Re: Harbor Grove Proposal, 9110 53rd Avenue W, Mukilteo

At your request, Landau Associates, Inc. (Landau) has completed a review of technical information and design documents related to the proposed Harbor Grove Subdivision Preliminary Plat project (project) located at 9110 53rd Avenue West in Mukilteo, Washington (site). Landau's review focused on which potential impacts on the hydrogeologic system and stormwater flows at—and in the vicinity of—the site have been adequately accounted for in the project design plans and documentation. Landau's review, described herein, is based on a site visit,¹ project design plans and other documentation provided on the City of Mukilteo's (City's) Land Use Action Notices website,² as well as project documentation provided on the City's separate website for this specific project.³ The City issued a Determination of Non-Significance (DNS) related to the State Environmental Protection Act (SEPA) requirements for the project on August 30, 2023. The City's DNS indicated that the City has determined the project "will not have a probable significant adverse impact on the environment that won't be adequately mitigated through application of existing cit

Figure 1 – Impact of Stormwater Pump System Failure on Rugosa Ridge Properties

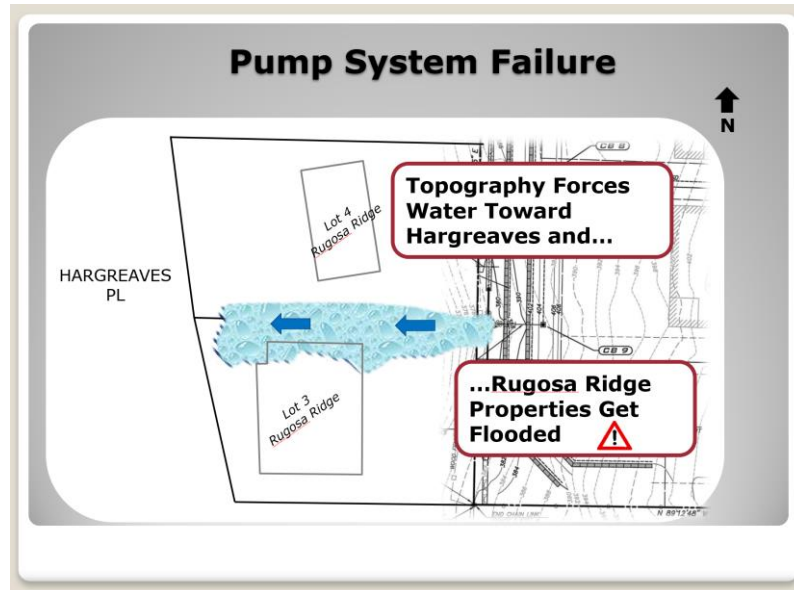
In summary, the City will have no control over how the future HOA conducts its business, which means it will be unable to prevent a pump system failure. There is a possibility the future Harbor Grove HOA will become inactive, meaning that it stops conducting meetings and collecting assessments from its members. Can the City really prevent this scenario and what would be the outcome if this were to occur?

The potential impact of a drainage system failure must be evaluated and avoided or mitigated.

Figure 2 – Illustration Showing Difficulty of Access to Improvements on Lot 6

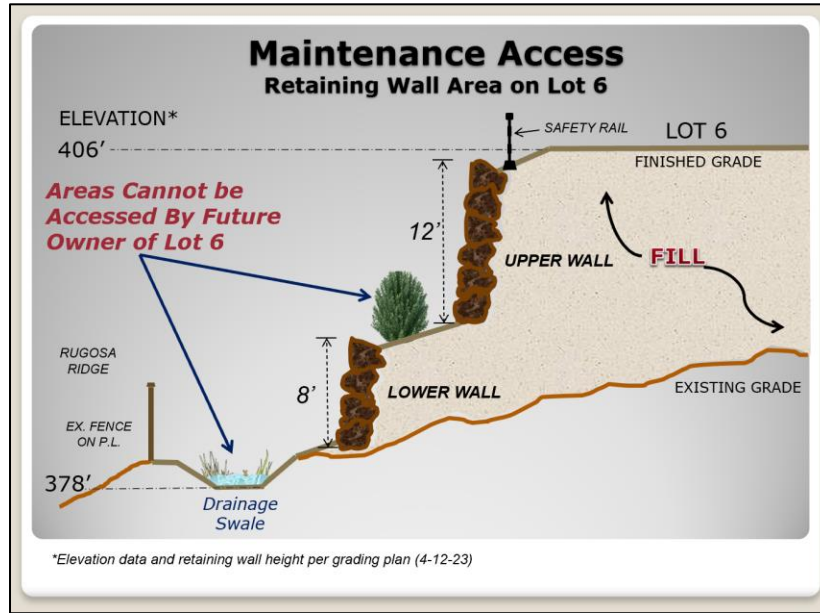
- b. Landscaping along western retaining walls. Regular landscape maintenance includes irrigation, debris removal, weeding, pruning and mulching. The proposed landscaping improvements located at the base of and in between the retaining walls cannot be maintained due to the height, length and location of the walls. No irrigation of the landscape areas is proposed (*see Landscape plans on file*). The continuous wall design will prevent the transport of materials and equipment to and from the landscape areas. The inaccessibility of this area will lead to accumulation of leaves, weeds and debris. Importantly, the landscaping will provide no tangible benefit to the future property owners of Harbor Grove since it will not be visible. It will only exist for the presumed 'benefit' of the residents of Rugosa

Ridge. This will greatly reduce the incentive for future residents of Harbor Grove to perform maintenance work. When the landscaping dies due to lack of maintenance and irrigation, it will become a visual nuisance that gets worse over time as dead plants, weeds and debris accumulate.

The use of covenants and restrictions to require maintenance of the landscaping in this area will be ineffective when the future homeowners cannot see it or gain access to it. The City would be approving a project design that creates a non-maintainable condition and becomes a source of conflict between existing owners in Rugosa Ridge and future owners in Harbor Grove. It is setting the stage for future enforcement action by the City and ultimate failure.

Figure 3 – Diagram showing location of retaining walls within rear setback

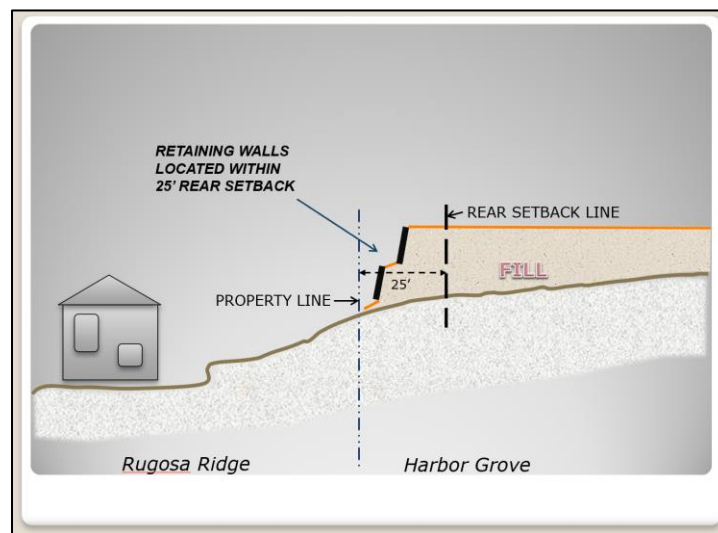
The proposed retaining walls along the western boundary of the project are located within the 25-foot rear setback required by the zoning code (*Figure 3*). The lower wall would be within 12 feet of the property line, while the upper wall would be within about 20 feet. The total length of the lower wall would be 170 feet, while the upper wall would be 250 feet. The combined height of the walls would be up to 20 feet on Lots 6 and 7, in the southwest corner of the project site. Both walls would exceed six feet in height in places. The purpose of the walls is to enable the grade of the site to be raised and leveled such that it is significantly higher than the surrounding properties.

The City maintains that retaining walls are not freestanding walls and therefore are not required to meet setback regulations for walls, fences or other structures (*Galuska email 2/3/23*). Under this reasoning, there is no limit to the height of retaining walls within setback areas. In other words, the Planning Department maintains the walls

Figure 4 – Building Height examples – with and without project

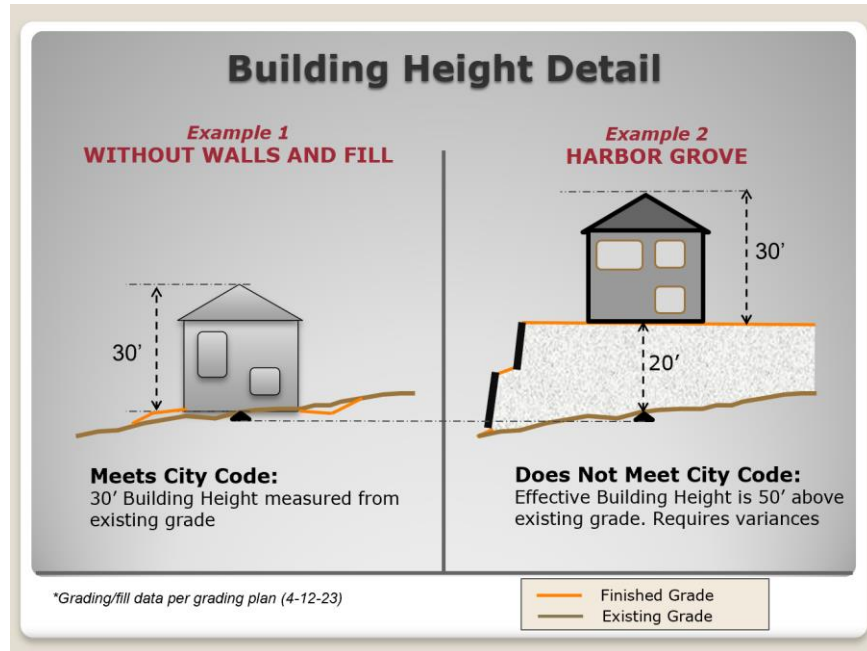
Under [MMC Section 17.20.020 - Structure bulk matrix](#) – maximum building height in the RD 12.5 zone is 30 feet from *existing grade*, as stated in the City’s requirements for building height calculation. The finished grade on Lots 4 through 7 is proposed to be elevated by up to 20 feet above existing grade. Calculation of building height based on the finished grade would result in future residences being allowed to have 30 feet of building height on top of 20 feet of fill for an overall height of up to 50 feet above the existing ground level (*Figure 4*). Applying the building height standard in this manner would be absurd and would create significant impacts on adjacent properties. It would amount to a building height bonus. Buildings located at or near the 25’ rear setback line would tower over neighboring houses and yards, resulting in light and shadow impacts and loss of privacy, use and enjoyment. These impacts have not been addressed or mitigated.

The definition of building height provides an exception for plats and short plats based on an approved grading plan; however, this is a discretionary review process that must consider the impacts that would result from the large-scale regrading of a site. The purpose and intent of this exception is to allow for minor changes within the interior of the site necessary for reasonable grading for utilities, roads and building sites, while protecting adjacent properties and the natural setting from harmful impacts of artificial increases in site elevation and building height. It recognizes the need to create smooth, rather than abrupt transitions around the exterior margins of a subdivision. It is intended to consider the balancing of cut and fill, rather than a net import of fill material (10,000 cubic yards) as proposed in the project. The building height exception connected to approval of a grading plan must be considered jointly with MMC 15.16 addressing grading and excavation. The City has applied the two sets of code provisions (zoning and grading) in isolation from each other in a manner that fails to consider impacts under SEPA and zoning.

Figure 5 – Slope Map Showing Approximate Breakdown of Slopes by Percentage

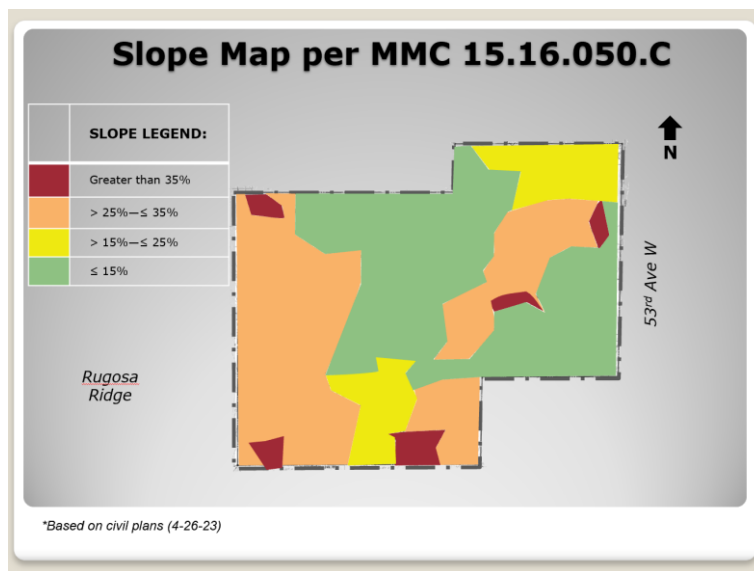
To meet the standards in Table 1 – Clearing Matrix, the application on file should have included a map showing a breakdown of on-site slopes according to steepness. Such a map can be prepared easily using Autocad or other common engineering software. See Figure 5 below, which shows the site to be anything but flat...

The application fails to comply with the requirements of MMC 15.16.050.C – Table 1 because it does not provide slope category and vegetation removal data. It uses the “average slope” of the property, which is incorrect because it does not acknowledge that a significant portion of the site is greater than 15% slope. The

Figure 5 – Map of Project Showing Location of Drainage System and Access Road

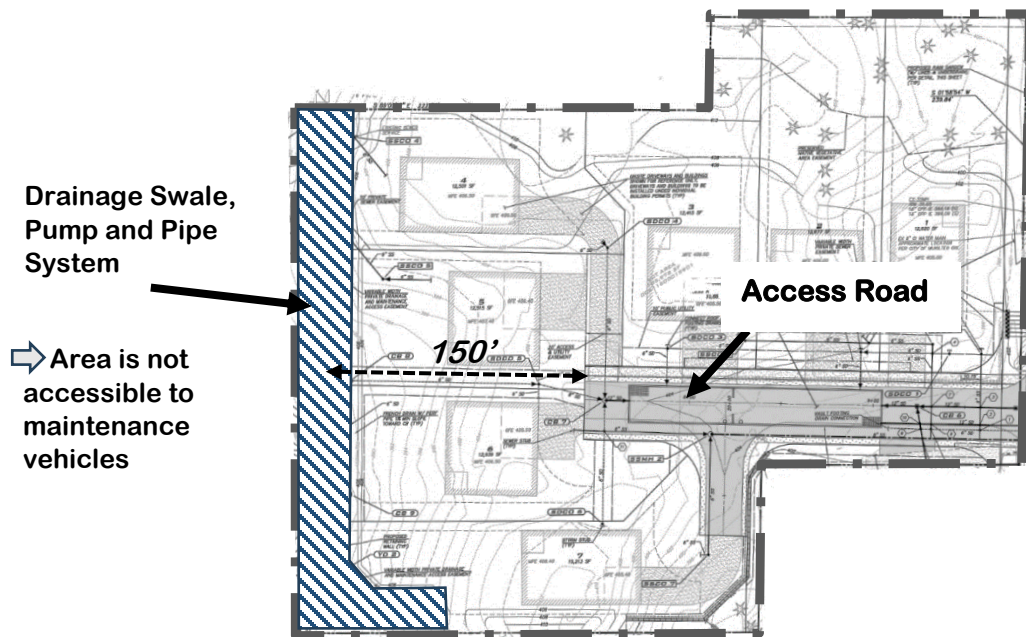
Analysis: The stormwater drainage swale, pump and pipe system will be located at the base of a large retaining wall and would be inaccessible from any road or driveway. The nearest road would be approximately 150' as the crow flies, and the actual travel distance on foot would be much further (see Figure 5 below). At this location, it would be physically impossible to provide vehicular access to this portion of the drainage system. As a result, all maintenance will need to be performed by hand and all materials and equipment will need to be hand-carried. This will greatly limit the type of work that can be performed and the frequency of maintenance.

The project design does not comply with stormwater facility access and maintenance standards because the stormwater pump system will be inaccessible to maintenance vehicles.

Proposed Developed Conditions from Drainage Report, April 20, 2023

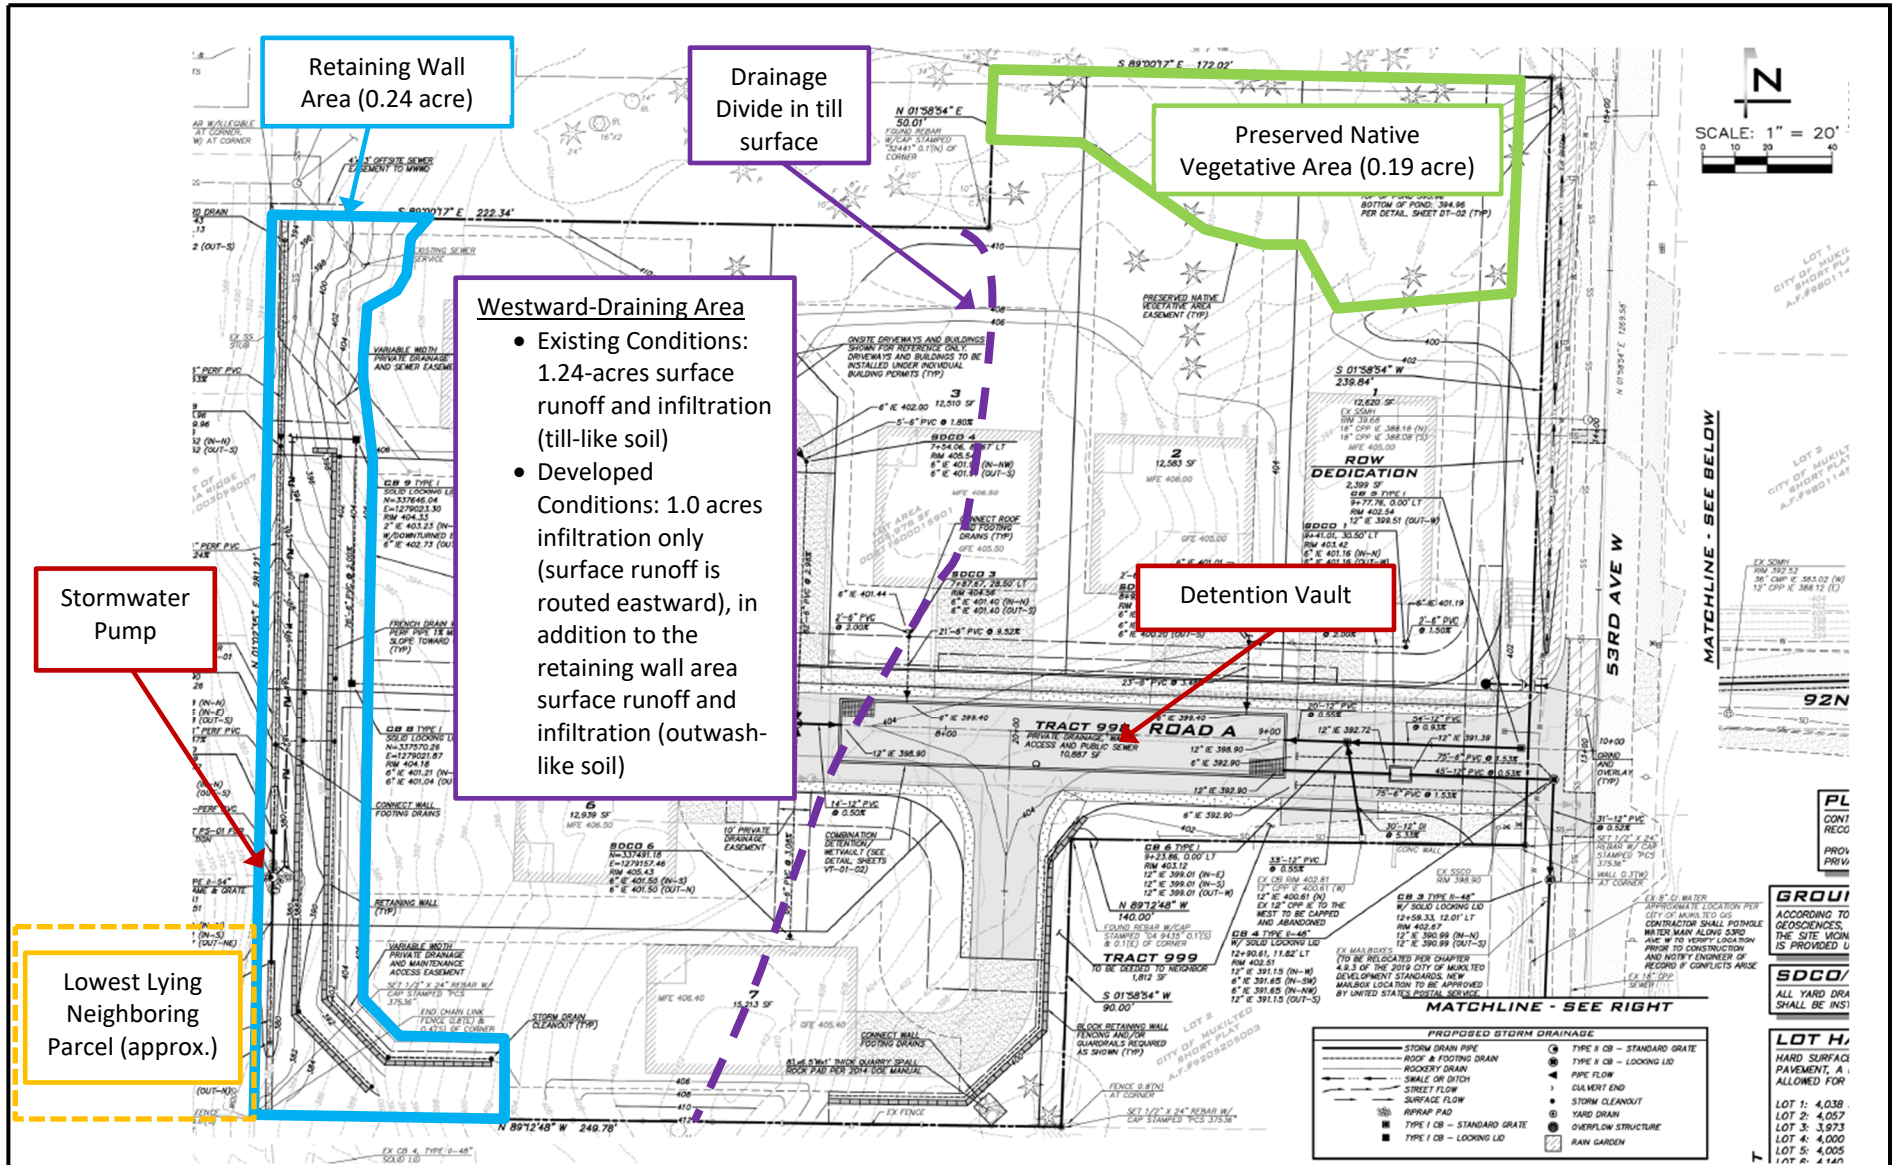
An important component of the site water balance⁵ that is not included in the Kindred simulation of proposed developed conditions is the portion of stormwater that infiltrates to ground and may travel laterally as shallow interflow (or perched groundwater flowing along the top of the till) that is likely to be collected by the retaining wall drainage and pump system. Kindred (2023) erroneously indicates that WWHM “does not provide estimates of groundwater recharge.” In fact, by toggling on the “compute recharge” option in WWHM, the stormwater infiltration component of the site water balance can be included in the WWHM output. Attachment 3 provides an illustration of several sequenced actions that can be done within the WWHM model setup to allow for infiltration output to be provided from a WWHM simulation. The stormwater infiltration flows from the retaining wall area would be appropriate to include in the design plans for the stormwater collection, conveyance, and pump system.

Along the same lines, the component of stormwater infiltrating to ground in the remaining 1.0-acre portion of the westward-draining area of the site under existing conditions (i.e., 1.24 acres of the Kindred existing conditions simulation minus the 0.24 acres of the Kindred simulation of proposed developed conditions of the retaining wall area; see Figure 1) would likely percolate downward from
